ADDENDUM NO. 02 TO THE CONSTRUCTION DOCUMENTS BID PACKAGE

Client: Arrowhead Regional Medical Center

Project: Oncology-Ambulatory Clinic

SHA Project No.: 18242.100

SHEET TITLE **DEMOLITION PLAN**

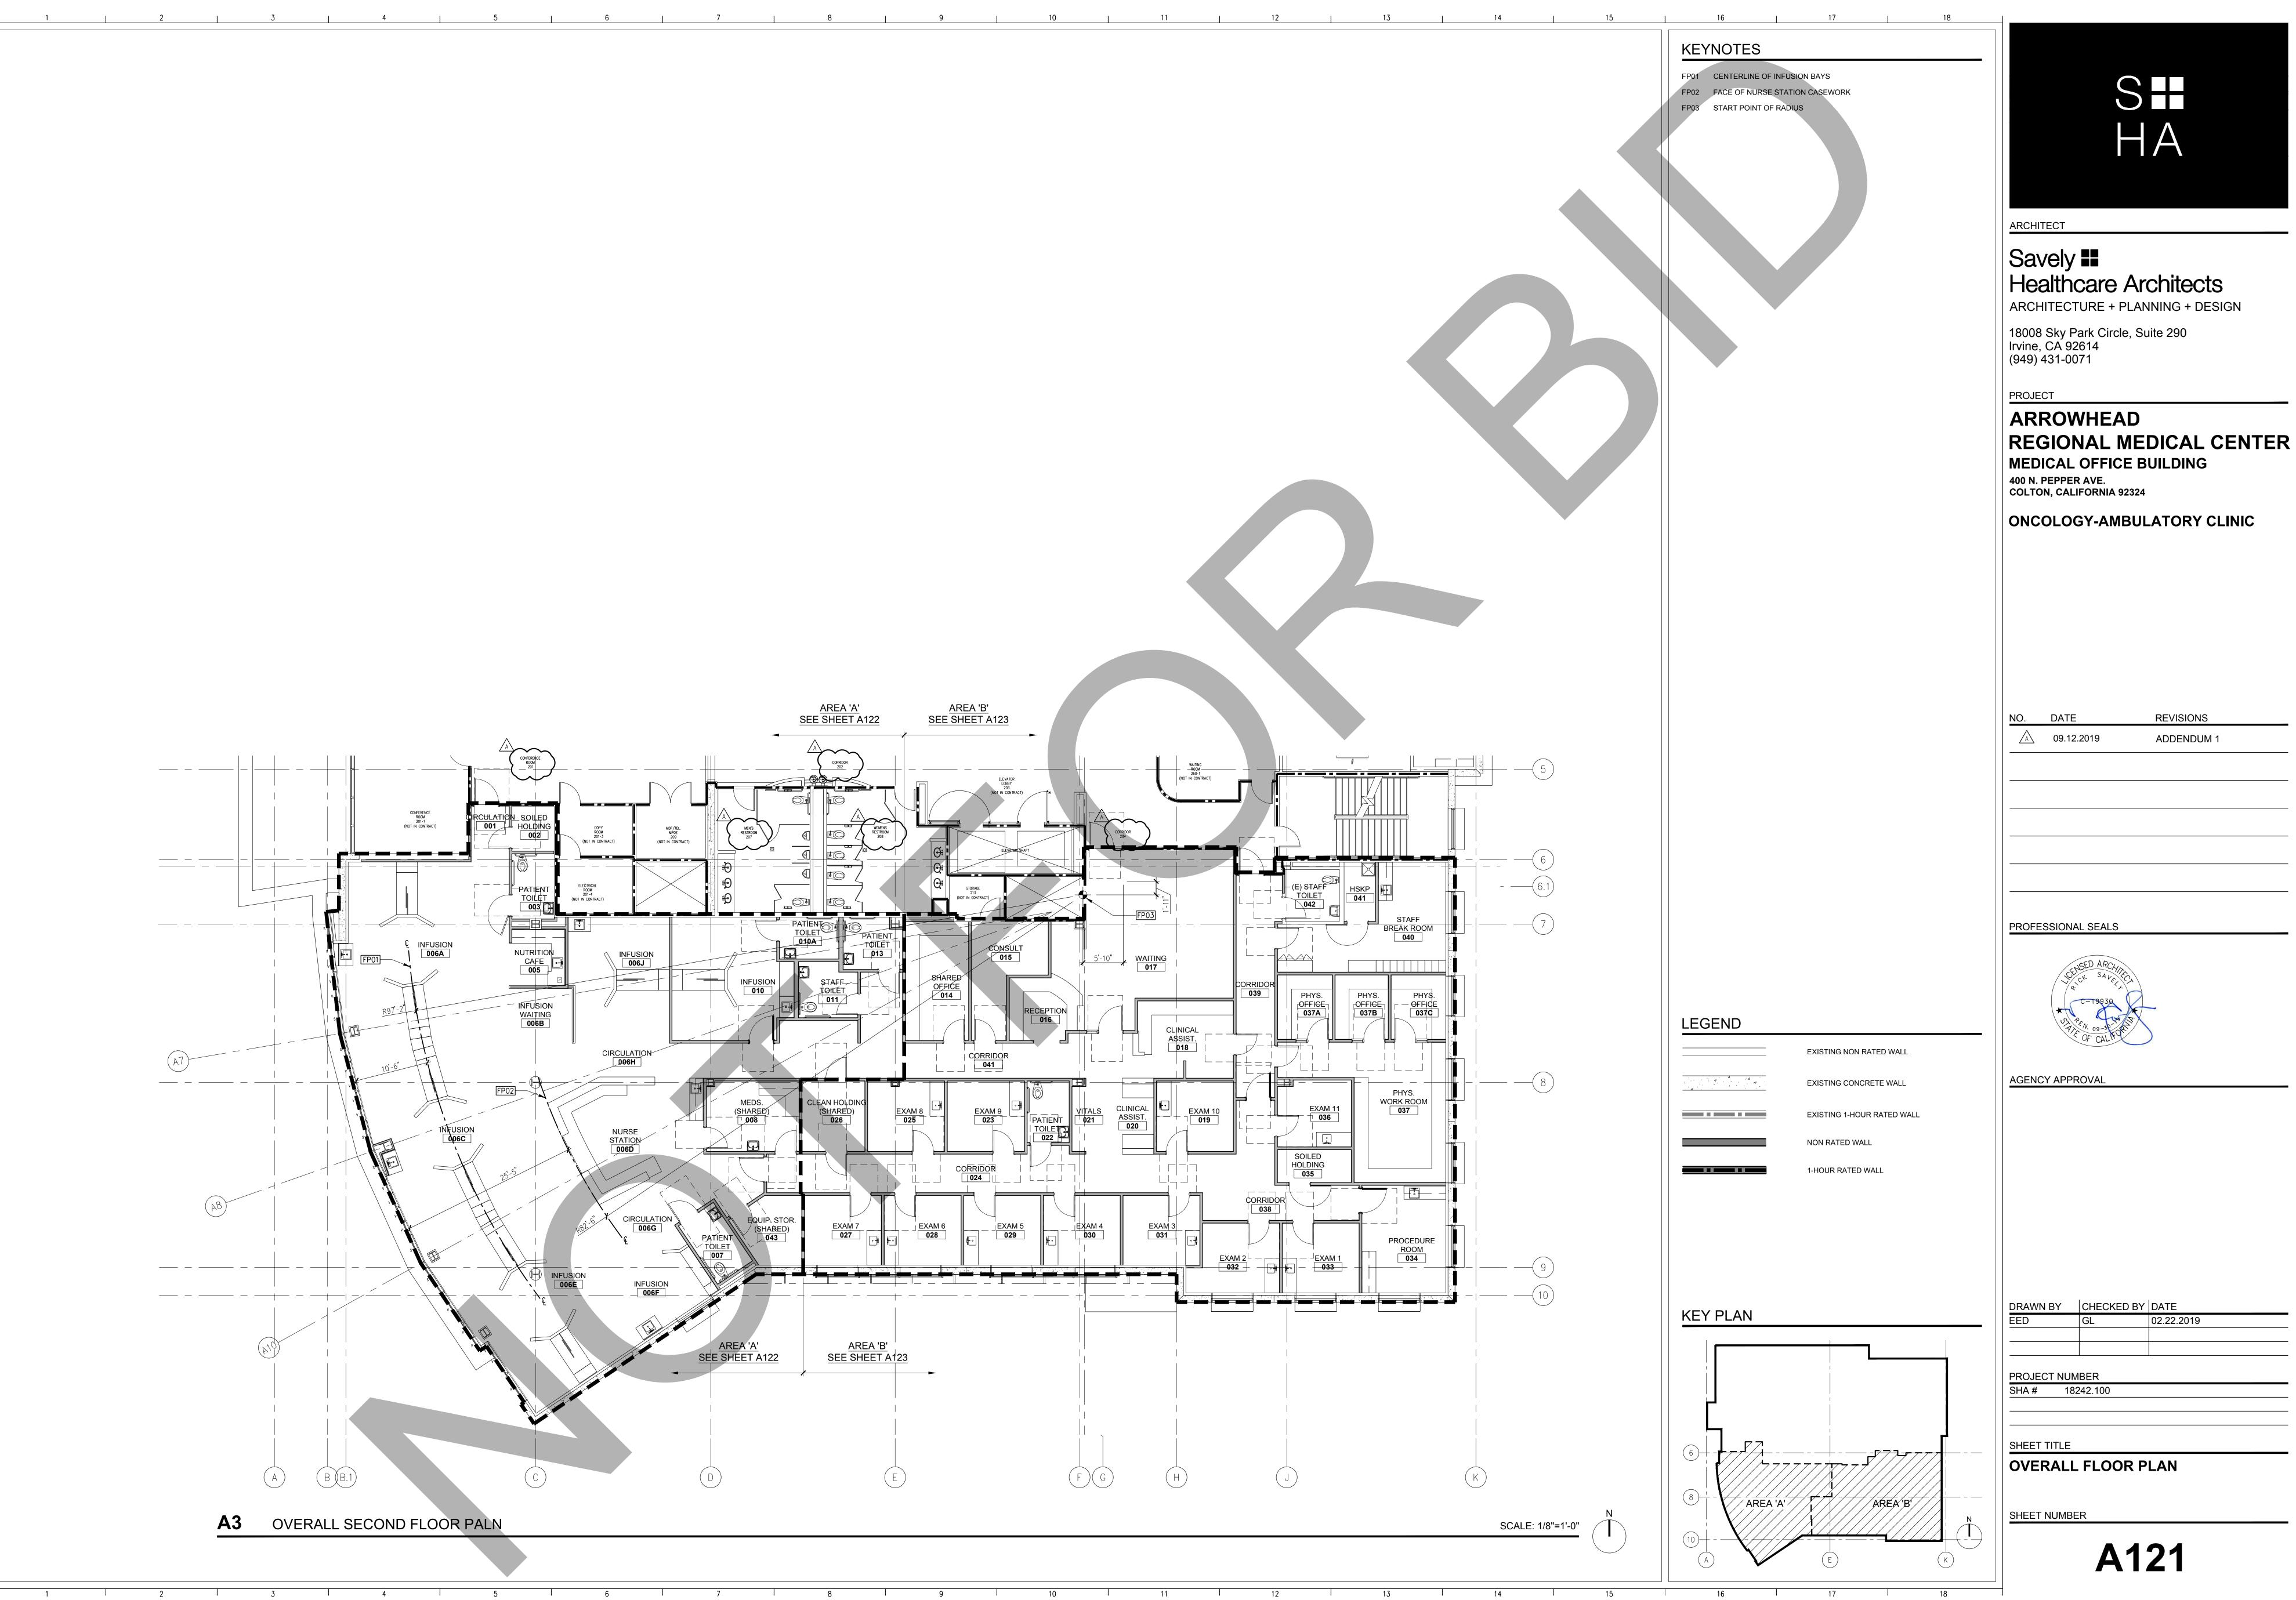
G001 Sheet names in List of Drawings revised to match sheets.
 A111 Existing room names added to the corridor that is to the north of the project area, scope revised to indicate partial demolition of the ceiling in this corridor.
 General Note added to sheet regarding accommodations for equipment or material deliveries and trash removal from the project area.
 A121 Removed "NOT IN CONTRACT" from room identification tags in rooms that require partial ceiling demolition.
 A122 Keynote FP06 revised to indicate new gypsum board at existing framing.

002.5	Sheet A111 DM15 shows removal of ceiling in restrooms 207 & 208. Sheet M122 shows these areas as "not in contract". Please confirm these areas are in the scope of work.	Keynote DM15 indicates to DEMOLISH EXISTING CEILING AS REQUIRED BY NEW MECHANICAL WORK ONLY. Coordinate with scope shown on Mechanical drawings. M122 should NOT indicate "NOT IN SCOPE". See revised Mechanical sheets attached.

007.1	Keynote DM04 on sheet A111 Demolition Plan calls to "Demolish Existing Gypsum Board On One Side Only, Protect Framing In Place" along the West, South & East perimeter walls, but keynote FP06 on sheet A122 Floor Plan - Area A calls for "Existing Gypsum Board Furring to Remain, Protect in Place. Please advise if existing gypsum board along the perimeter wall is to remain, or to be demolished and replaced with new framing and drywall.	Existing gypsum board along all perimeter walls is to be demolished. FP06 on sheets A122 and A123 has been revised to indicated existing framing with new 5/8" gypsum wall board

FLOOR PLAN - AREA 'B'

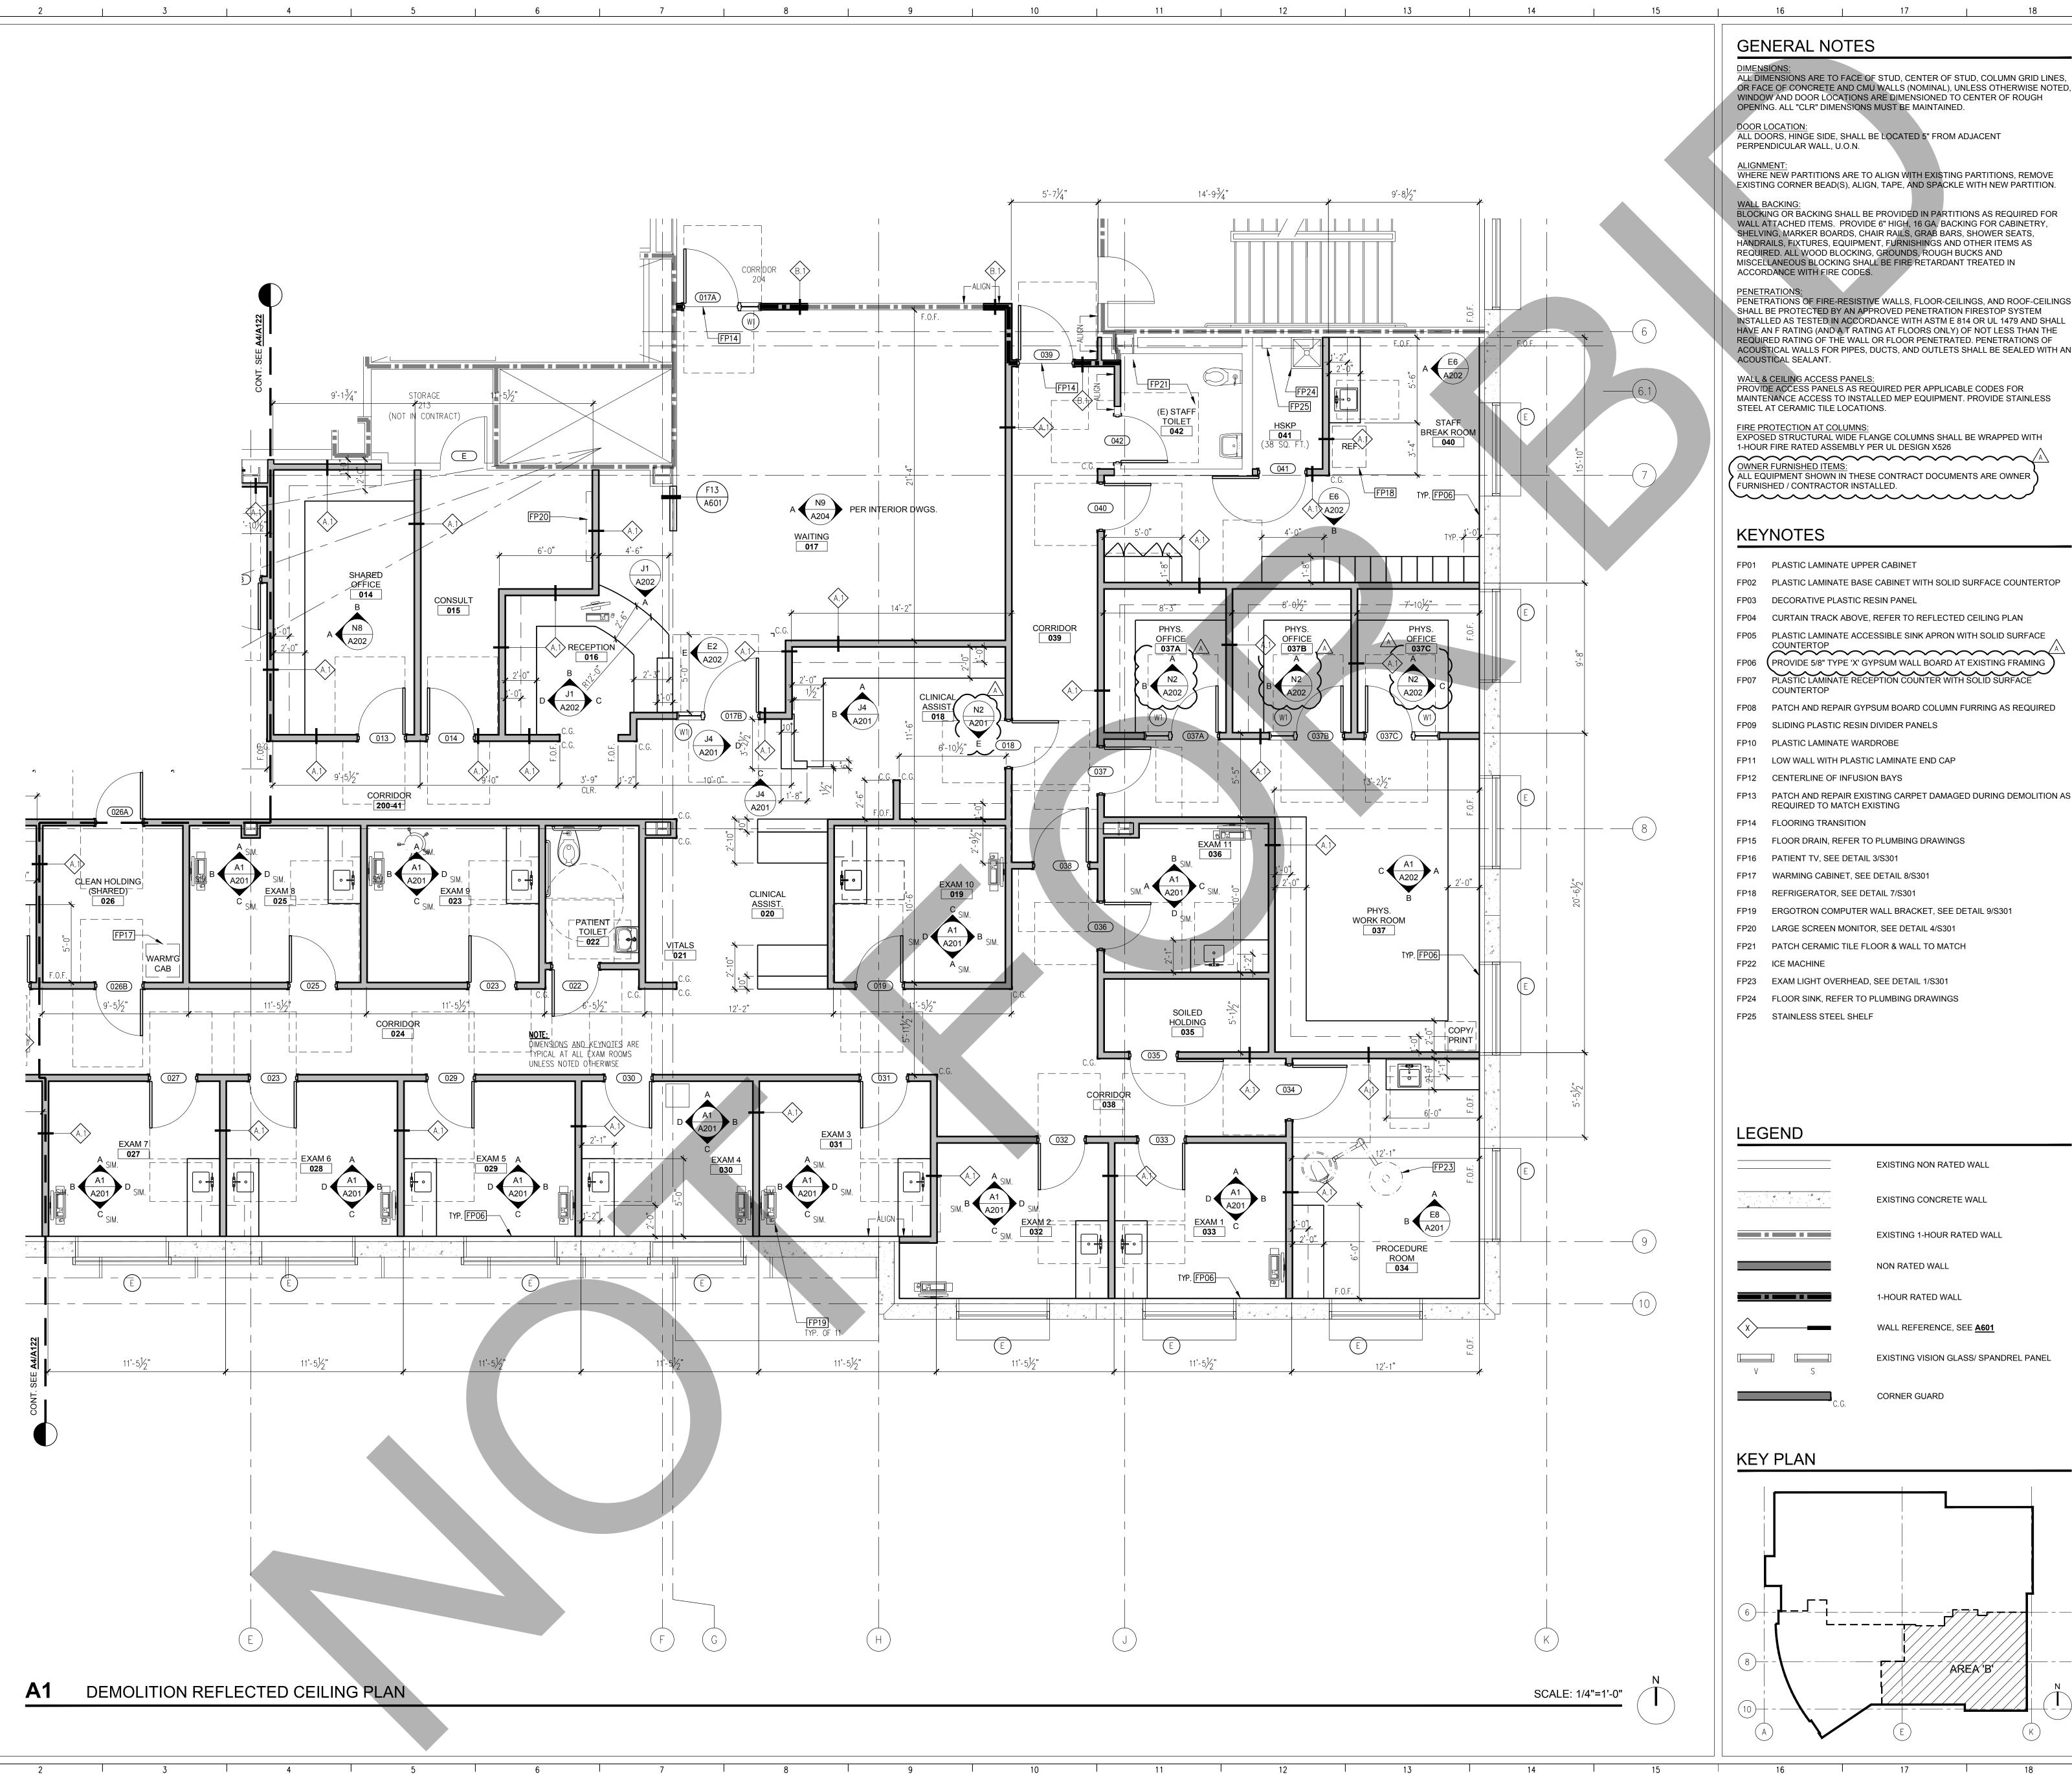
- A123 Keynote FP06 revised to indicate new gypsum board at existing framing.
- A131 General Note added to sheet regarding patching back of existing ceilings in corridor. General Note regarding Owner Furnished Items added to General Notes.
